OBSERVATION:
THE DS/CLT EDGE PROFILE, WHERE THE FACADE CURVES, IS NOT SATISFACTORY, AND THE EXECUTION OF THE PROFILE AND FINISHED APPEARANCE IS NOT APPROVED BY BIG AND LUX AIRPORT. THE DISSATISFACTION WITH THE APPEARANCE OF THIS DETAIL RESULTS FROM THE OVERLAP OF THE PROFILE, WHICH CREATES A DISTINCT LINE PROJECTING STRAIGHT OUT FROM THE CURVED CLT EDGE. WHEN THIS STRAIGHT LINE MEETS THE CURVED EDGE OF THE CLT, IT PRODUCES MULTIPLE ANGLES THAT CREATE THE APPEARANCE OF TWO SEPARATE OVERLAPPING PANELS, CREATING AN INCOHESIVE AND UNFINISHED LOOK. ADDITONALLY, THE VARIABILITY IN THE WIDTH OF THE RECESSED PORTION OF THE PROFILE AT THE CURVES CREATES INCONSISTENCY WHEN COMPARED TO THE STRAIGHT PORTIONS, MAKING IT APPEAR UNCLEAR AND INCOHERANT AS AN ENTIRE SYSTEM.

COMPARISON OF RECESS IN PROFILE AT STRAIGHTS AND CURVES

PROFILE IS ACCEPTED

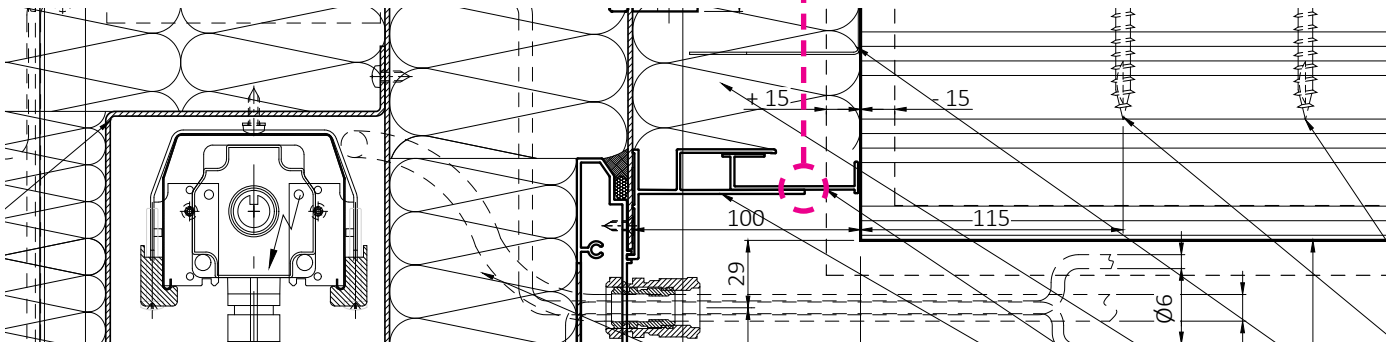
ON THE STRAIGHT PORTIONS OF THE FACADE, THE EXECUTION AND FINISHED APPEARANCE OF THE PROFILE IS SATISFACTORY AND APPROVED BY BIG AND LUX AIRPORT.

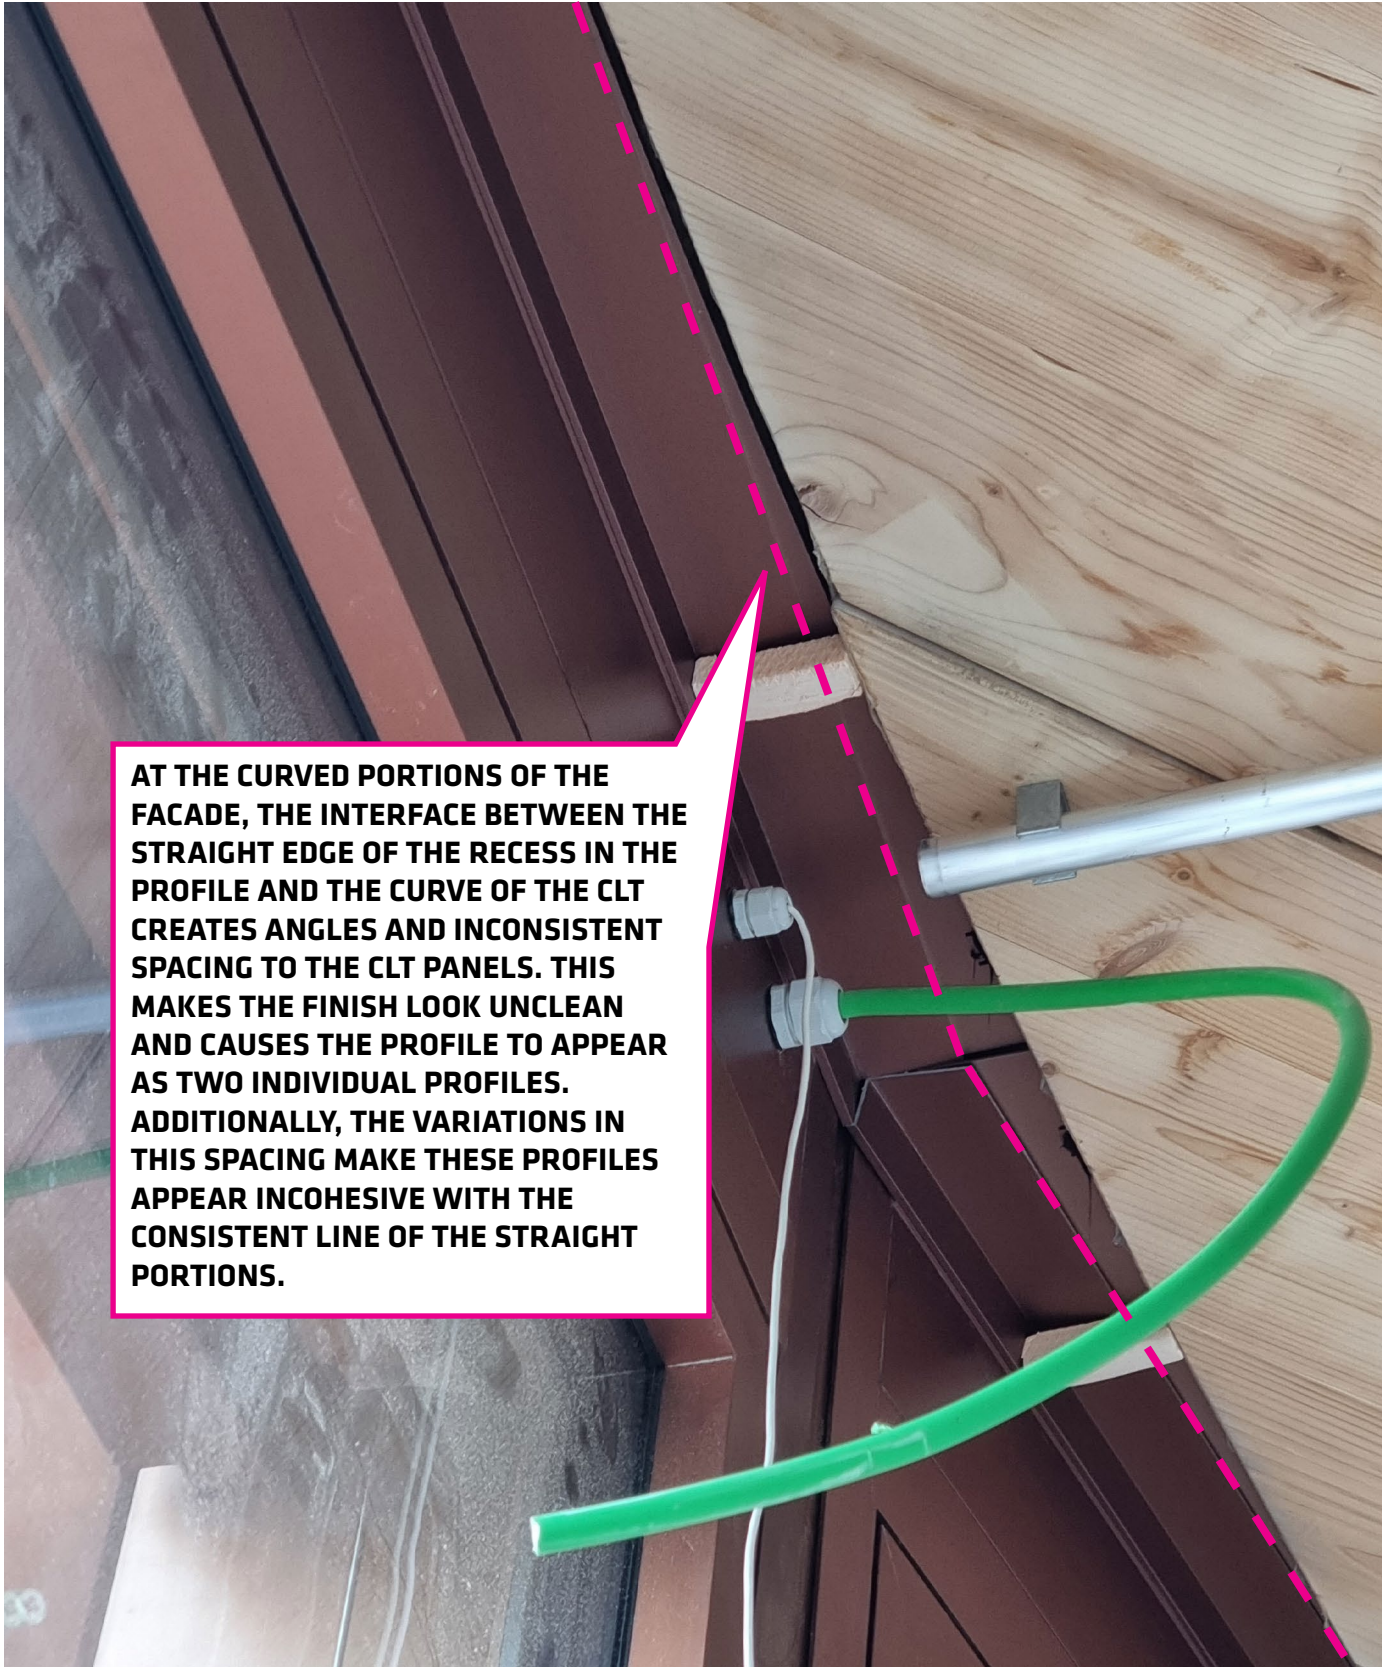
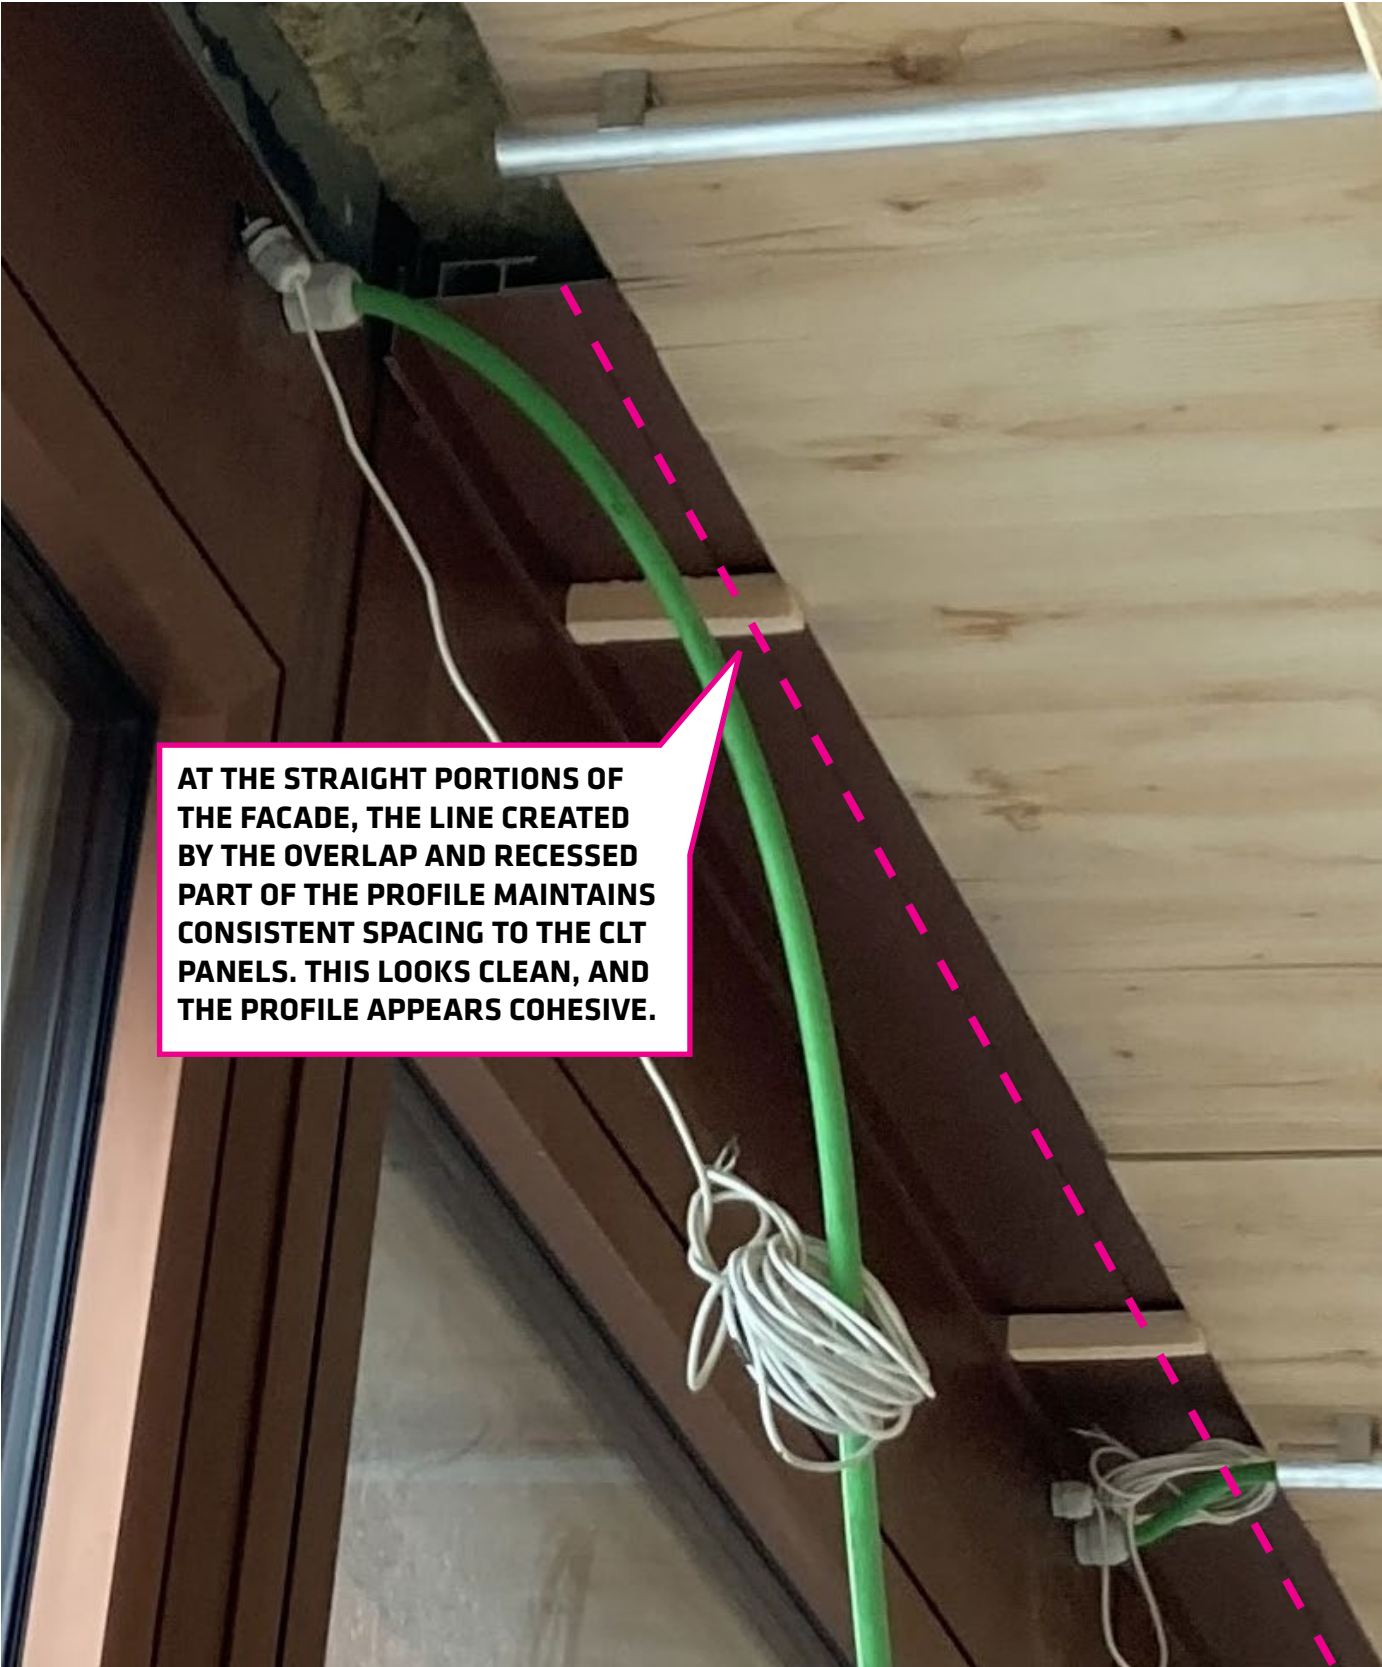
PROFILE IS NOT ACCEPTED

ON THE CURVED PORTIONS OF THE
FACEADE, THE OVERLAPPING AND
RECESSED PARTS OF THE PROFILE
PRODUCE VISUAL EFFECTS THAT
ARE NOT SATISFACTORY AND NOT
APPROVED BY BIG AND LUX AIRPORT.

PROPOSED SOLUTIONS

SUGGESTION 1:

PRODUCE A RECESSED PROFILE THAT FOLLOWS THE CURVE OF THE CLT WHILE ALSO MAINTAINING A CONSISTANT DISTANCE FROM THE EDGE OF THE CLT. IN THIS CASE, THE GAP BETWEEN THE CLT AND THE RECESS IN THE PROFILE SHOULD BE EQUAL ON BOTH THE STRAIGHT AND CURVED SECTIONS.

THIS MAY BE DIFFICULT DUE TO THE FACETING OF THE FACADE.

SUGGESTION 2:

ELIMINATE THE RECESSED PORTION OF THE PROFILE AND EXTEND THE BACK OF THE PROFILE TO THE EDGE OF THE CLT PANELS. THIS WILL ELIMINATE ANY LINES AND ACHIECVE A CLEANER AND MORE COHESIVE APPEARANCE.
